Re: 126A High Street, Clophill, Beds

Application No: CB/14/01271/FULL

Re: CB/14/01271/FULL Demolition of bungalow and erection of 4 bedroom detached dwelling at 126A High St, Clophill

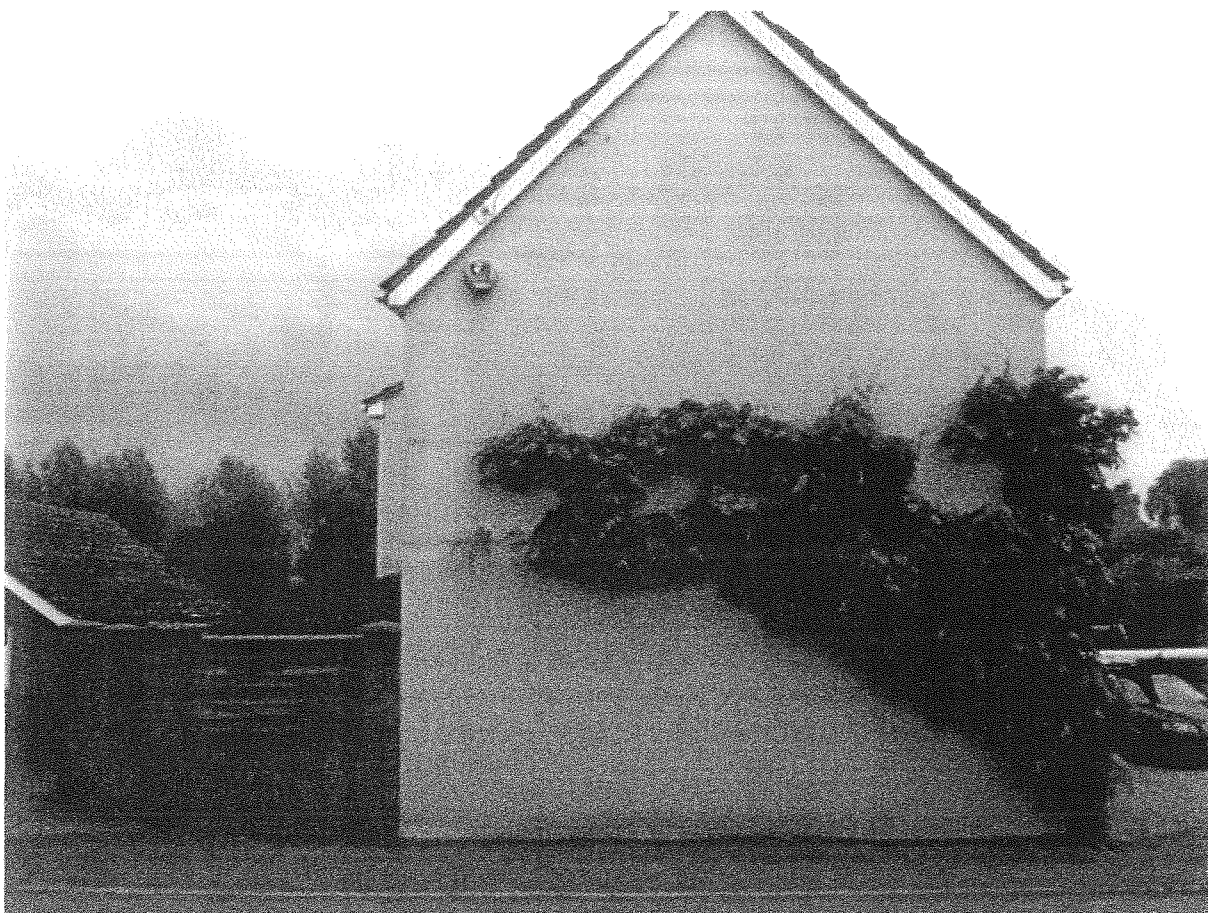
Agenda item 6, page 17 : Size, siting and design. Paragraph 1 – the width of the plot at the road is 10.8m. The proposed 9.7m house fills nearly all of the width, not just 'much' of the width as stated in the report.

Paragraph 2 states the main depth of the proposed house is 13m. I wish to clarify that it is in fact 14.3m from the front of bedroom 1 to the rear of the lounge dining room.

Paragraph 3 – this suggests that the 9.7m wide house will have 1.1m and 1.2m either side of it, making a total width of 12m. Given that the plot width on the front line is only 11.477m wide as measured with a laser, this maths does not add up. These kinds of discrepancies are unacceptable, because of the consequence on our amenity. We also pointed

Also in paragraph 3, I wish to dispute the 3.5m mentioned between our utility and kitchen windows and the proposed wall that faces it, which incorporates their kitchen window and kitchen door, as it is closer to 3m when you take into account the above paragraph and the fact that our breakfast room is still not shown on the site plan with which you have been provided. This means our home is 800mm closer to the boundary. Our breakfast room is 1m from the boundary fence, and NOT 1.9m. It is important that the dimensions are correct, due to the assessment that then needs to be undertaken.

I can only really answer his questions on discrepancies; the other items are generally matters for the officers. I would point out that the property at 126A and its immediate surroundings i.e. part of 126 and part of 128 was carried out by a highway reputable company of land surveyors (Kempston Surveys Ltd) as can be seen on the title heading of their drawings as submitted, DRG. ID. 100 Plan No1 existing and DRG. ID. 100 Plan No 2, with my notes added.

The survey is extremely accurate and the comments made by the occupant of 126 quite frankly are mistaken. It may be that he used scaling from a reduced copy from the website which cannot be scaled. He gives his own dimensions that are inaccurate for example, I quote, 'the width of the plot at the road is 10.8m', the actual width is 12.6m. With regard to his paragraph 3, the point on the site where the full width of 9.7 occurs the plot width is 12m not 11.477.

With regards to his references to the officer's report, it is not for me to answer, however I will point out that he states that his breakfast room is not shown on the plan, my understanding is that it is and later on he states that the breakfast room is 1m from the boundary and not 1.9m. The drawing shows by scaling that 1m is correct, as it is shown on the plan, I do not know where he gets 1.9m from?
